**SUBJECT: REVISION "A" TO TECHNICAL BULLETIN 212-00-184:
FIN SPAR CAP 212-030-125-001 & 212-030-447-001/ -101,
REPLACEMENT OF**

No. 212-00-184

REV A

SUBJECT: FIN SPAR CAP 212-030-125-001 & 212-030-447-001/-101, REPLACEMENT OF

Figure 2

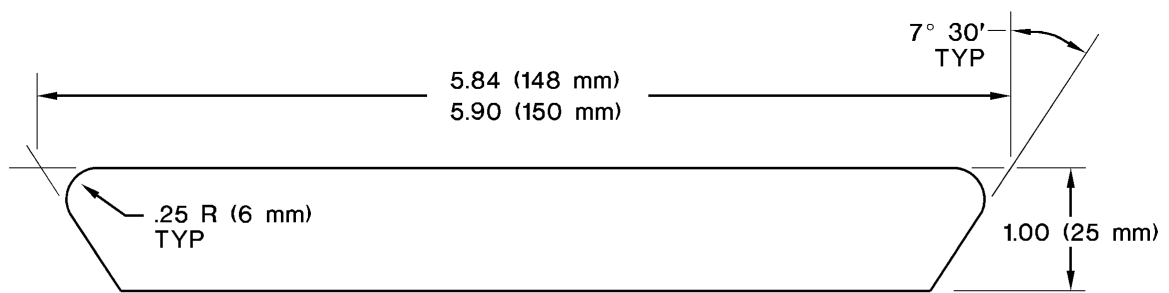
6. Remove the (qty 8) MS20426AD3 rivets that attach the 42-degree gearbox attach nutplates to the supports and skins, if required. Referring to figure 2, remove doubler P/N 212-030-099-089/-129 and skin P/N 212-030-099-087/-131, by removing fasteners securing parts to tailboom. Slide skin and doubler assembly aft up along spar until clear of bulkhead and tailboom skin. Slide assembly forward, then slide parts from under angles P/N 212-030-137-017 and -021. Clean sealant from parts using plastic scraper, Scotch-Brite and Methyl-Ethyl-Ketone. Verify that skin and doubler assembly is still properly bonded. Refer to ASB 212-93-85.
7. Remove rivet attaching stiffener (tie angle) P/N 205-030-801-007 to left support P/N 205-031-832-004. Refer to figure 2, view A-A.

26. Prime any bare metal with primer (C-204).
27. Locate new support P/N 212-030-446-001S, fillers P/N 212-030-099-157 and 212-030-099-159 in place on skin and doubler and against face of spar as shown in figure 2, view A-A. Check edge distance on forward most holes in the 212-030-446-001S support (see figure 2, view A-A). If edge distance is less than 1.5, make a shim as shown in figure 3 and install it on top of filler 212-030-099-159. Transfer existing holes from structure. NAS9310M5 or M7885/8-5 fasteners (qty 10 required) may be used for the installation of the 212-030-446-001S support horizontal flange to the top of the tailboom skin and doubler. See figure 2 view A-A. Install fasteners with wet primer (C-204).

Figure 4

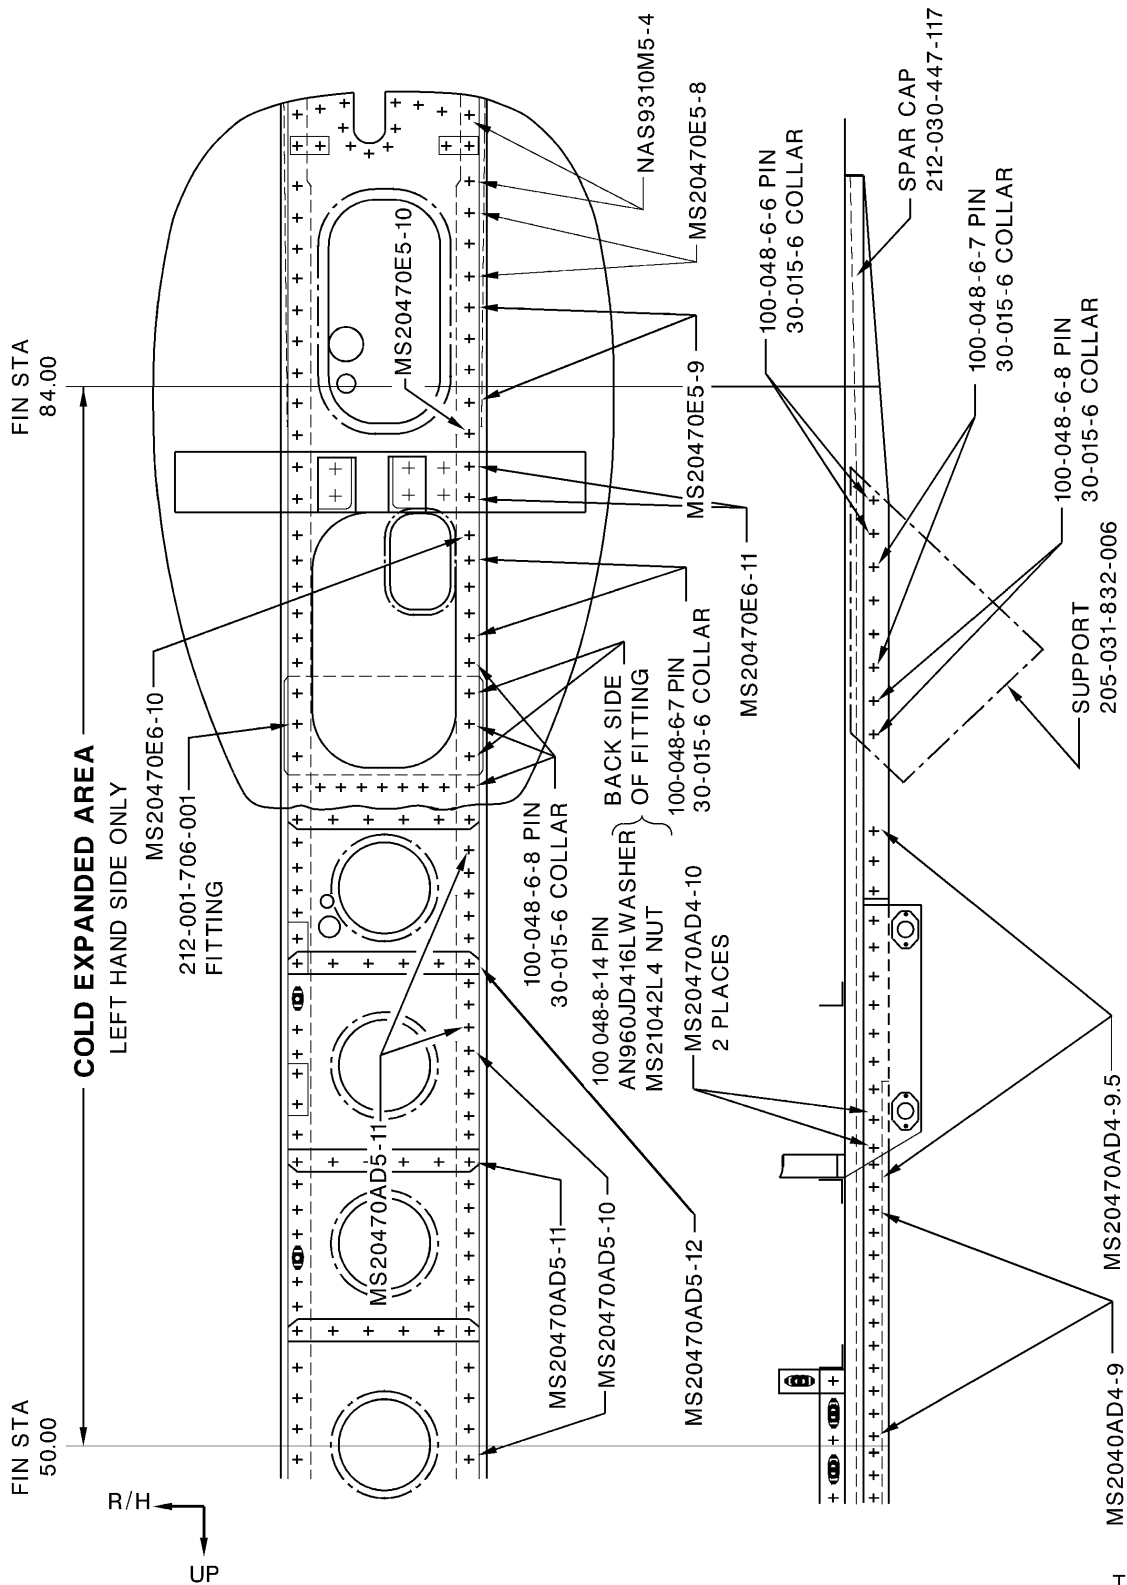
Do not transfer holes at the bellcrank support attachment locations as nutplates will be replaced with Hi-Lok pins (refer to figure 4).

21. Install remaining fasteners attaching the left forward vertical fin spar cap to spar web as shown in figure 4.
22. Remove nutplates from R/H spar cap at bellcrank support locations and replace with Hi-Lok pins as per TB 212-86-92, if not previously accomplished.

Figure 5

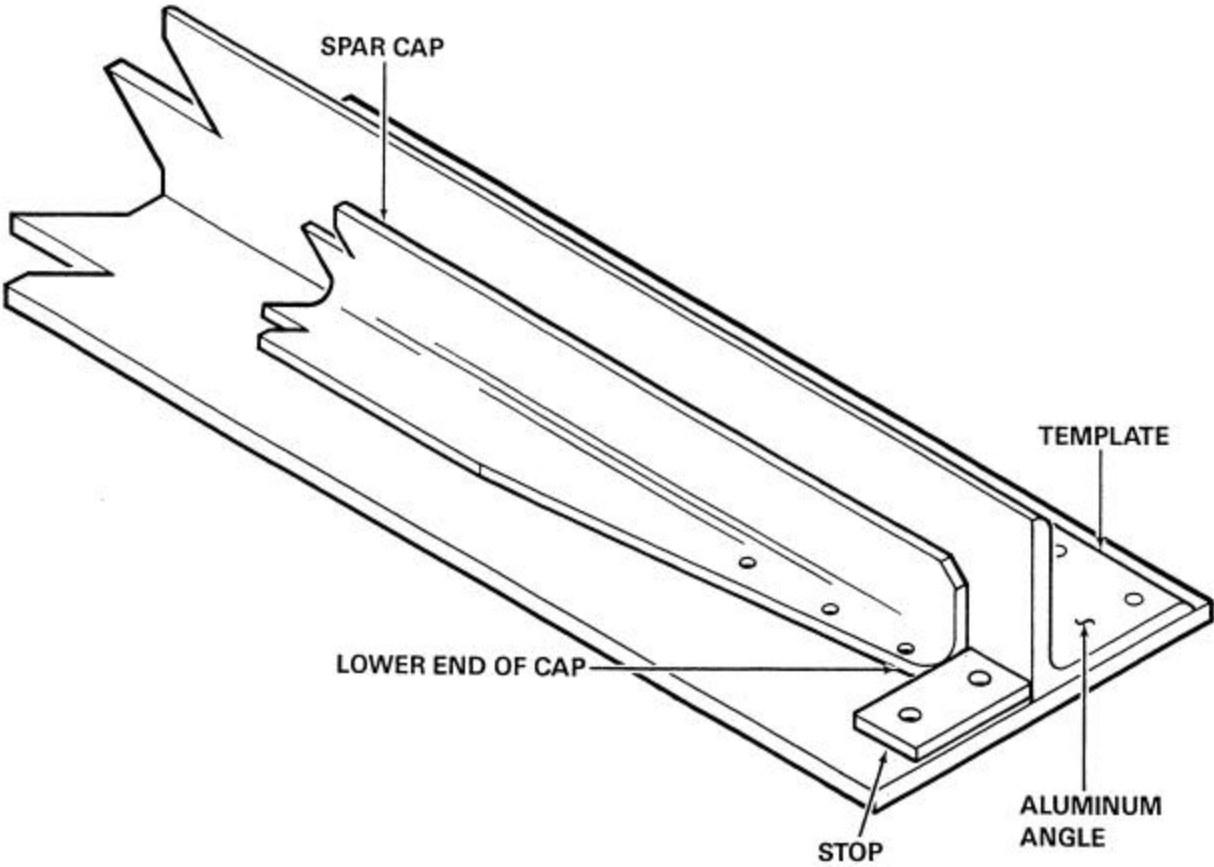
11. Inspect all existing holes in the removed cap for minimum edge distance of 1.5 (refer to attachment B and C). Any hole with low edge distance in the cold expansion area will be identified and not transferred to the template. It will be relocated in the cap to obtain a satisfactory edge distance. A small local repair can be done to the adjacent sheetmetal using instructions in chapter 3 of the "Structural Repair Manual". This inspection will also apply to any hole that will be oversized in later steps.
12. Fabricate spar cap drill template per figure 5.

- c. Spray template with machinist ink or any suitable coating to provide surface for marking template.
- d. Place bottom end of spar cap on strap against stop with other leg against angle (refer to figure 5). Clamp in place. Make a note of the clamping sequence so that the same sequence may be used in later steps. Scribe a line around the spar cap on the template as a reference.

Figure 6

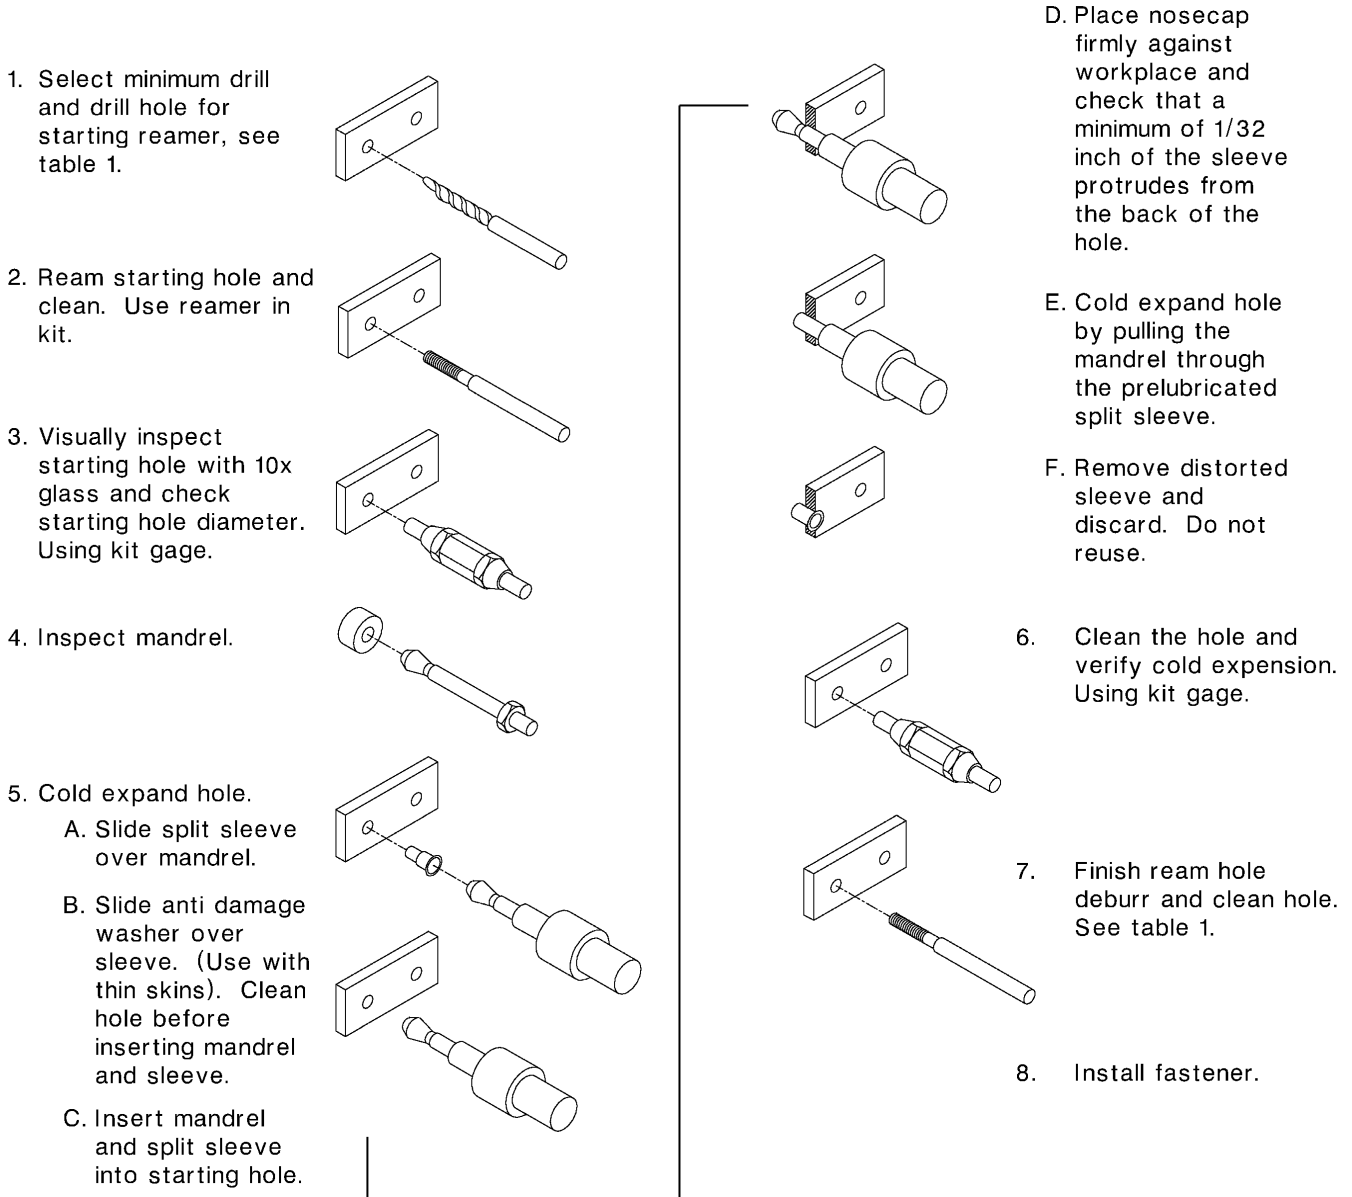
- 13. Clamp new spar cap P/N 212-030-447-117S in place in template. Scribe a line around the new cap to compare to the line scribed from the old cap. This is used only as an indication of edge distance problem areas. The new cap should be marked with a pencil or marker prior to drilling to verify all edge distances.
- 14. In cold expansion zone of the new spar cap, pilot-drill Cx start-drill holes from template. Using drill block, open holes to Cx start-drill size. Do not use drill block on Hi-Lok holes except for holes common to new support P/N 205-031-832-006 (replacing -004 support). Do not open (qty 2) holes common to bellcrank support at this stage. Carry out Cold Expansion process on holes in specified area (refer to figure 6).

Any hole that does not meet requirements of step 7 of figure 6, attachment B and table 1 dimensions will be cause for rejection of entire spar cap. Therefore, it is advisable to complete the Cold Expansion process before other holes are drilled.

Figure 7

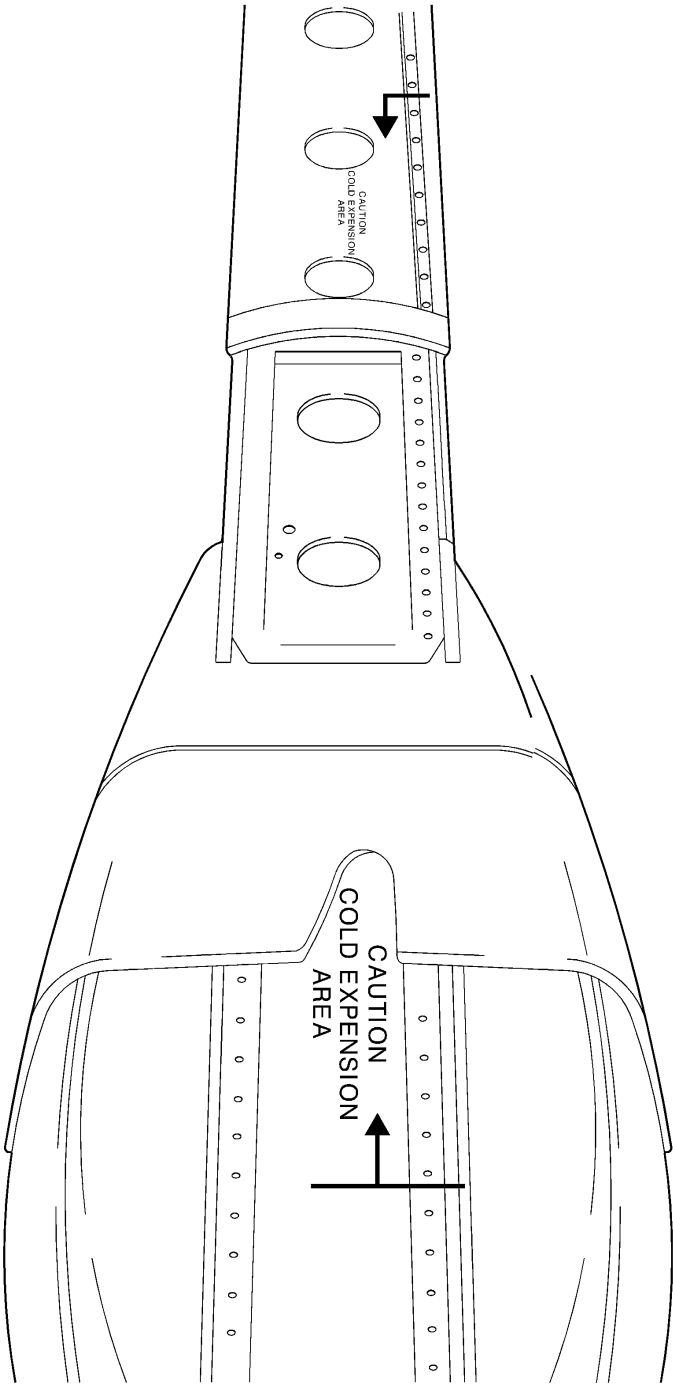
34. Install decals as shown on figure 7. **"CAUTION COLD EXPANDED HOLES"** decals at Fin Station 50 shall be pointing down and at Fin Station 84, pointing up. A paint stencil may be used instead of the line decals as follows: paint a 1/8-inch red stripe over the spar and onto the web at Fin Station 50 and at Fin Station 84. The arrows should touch these red stripes. Coat decals with clear lacquer (C-349).

Figure 8

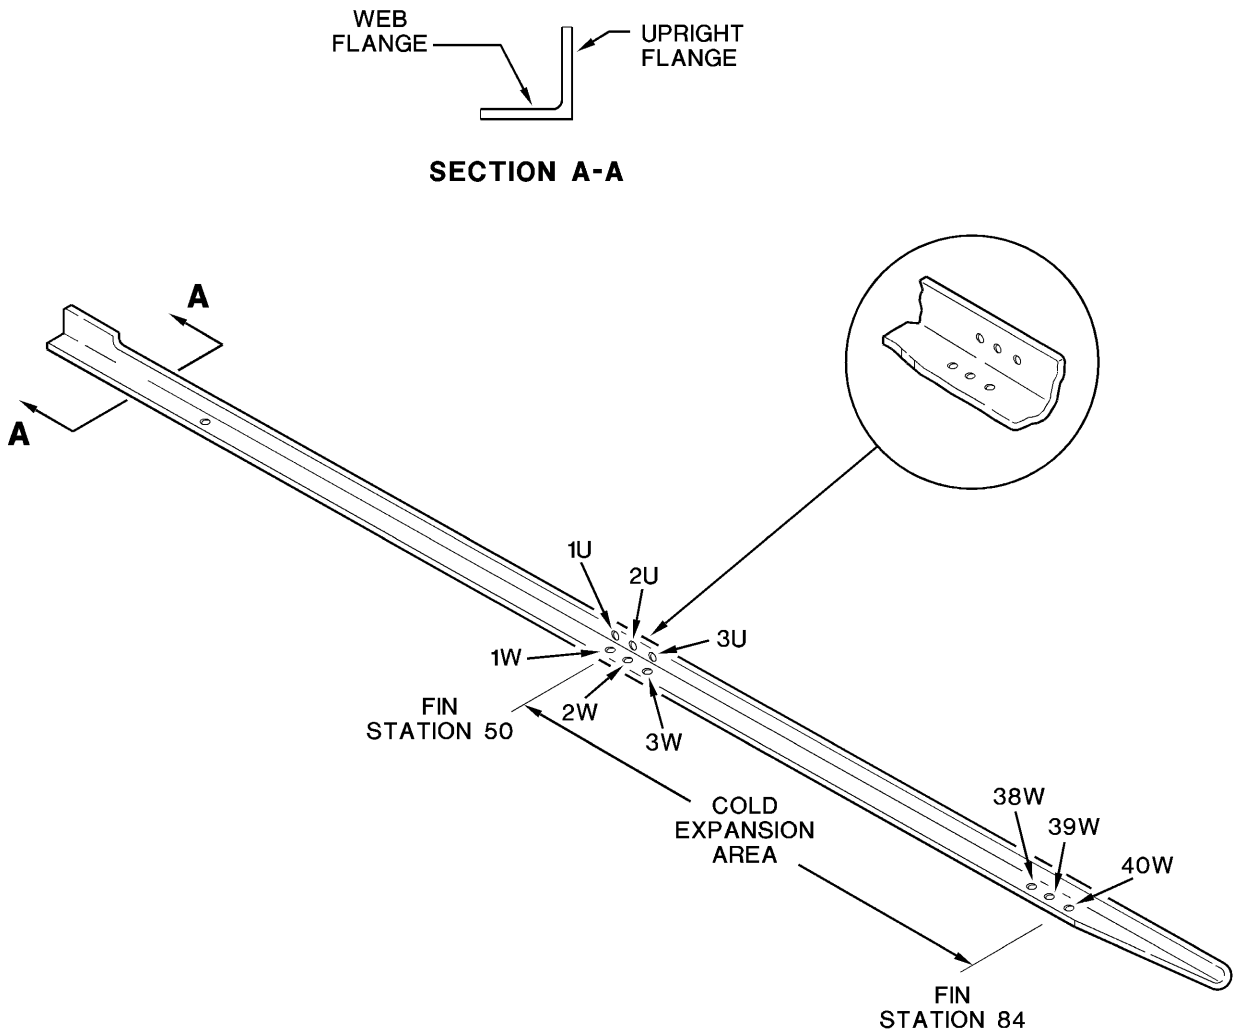
8. Identify area to be cold expanded with a grease pencil, or other suitable marker, from Fin Station 50 to Fin Station 84 on both the cap and the web. Record current fastener data in the cold expansion zone using the "MODEL 212 FIN SPAR COLD EXPANSION (Cx) * LOG". Refer to figure 4, attachment D and figure 8.

1. Column 1, "Fastener Location", identifies all fasteners in the cold expansion area starting at Fin Sta. 50. The fasteners on the upright leg are numbered 1u to Xu (generally 33 fasteners). The fasteners on the web leg of the spar cap are numbered 1w to Xw (generally 40 fasteners). Refer to figure 8.
